Ducted Systems Technical Services: Service Tips Letter

Letter: ST-012-21

Subject: **Commercial- Condenser Fan Motor Mounting Ring Locations and Torque**

Product/s: Select 27.5-50T All Brands, YH/YV, UH/UV, TH/TV, JH/JV
Premier 25-80T All Brands, GZ, GV, GT

Figure 1

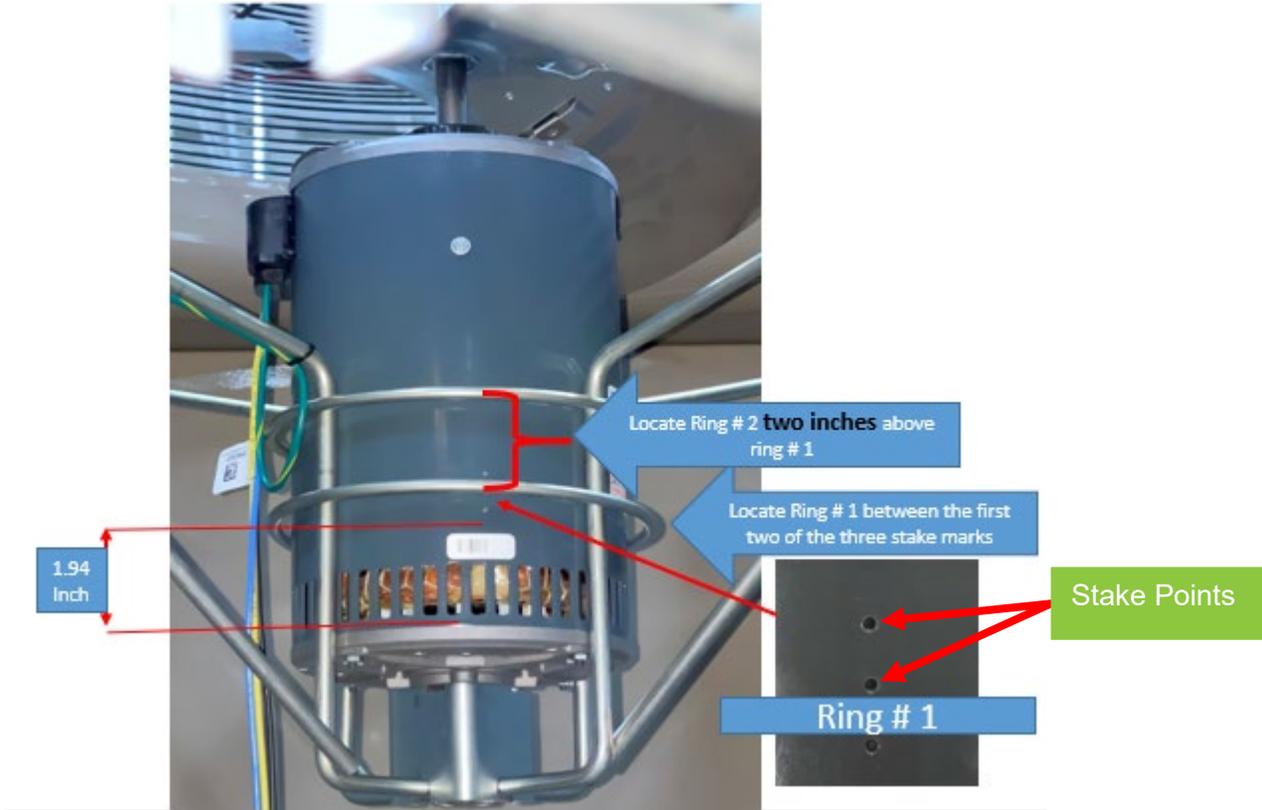
Use this diagram as reference when replacing a condenser fan motor on Select or Premier to correctly locate mount rings and torque the rings properly.

Figure 2

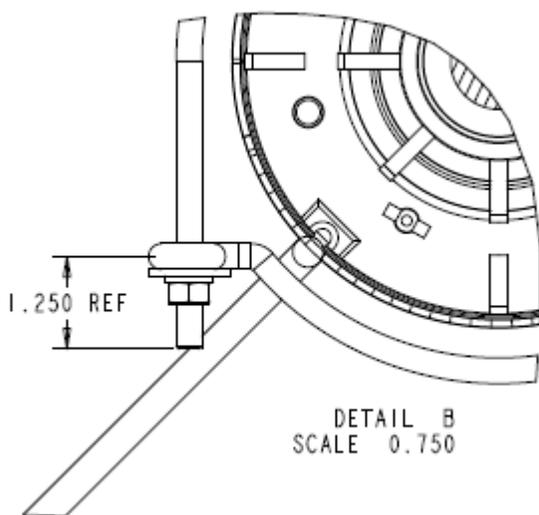
The above-listed products use two condenser fan motor horsepower's (1hp and 2hp). Ring locations are determined in the same manner for both motors. The motor manufacturer uses stake points to retain the stator inside the motor housing. These stake points are easily identified on the outside of the motor and resemble dimples in the housing as shown in the inset of figure 1 on the following page. The lower mount ring is to be located between the first and second stake points as indicated in this same inset. The second ring is to be mounted 2" above the first ring. These locations will place the rings within the stator of the motor where the motor housing is most rigid. Tighten the nuts for each ring per the specification shown in figure 2 of 1.25" from the center of the eyelet to the tip of the stud, this will apply the proper torque to secure the motor without damage.
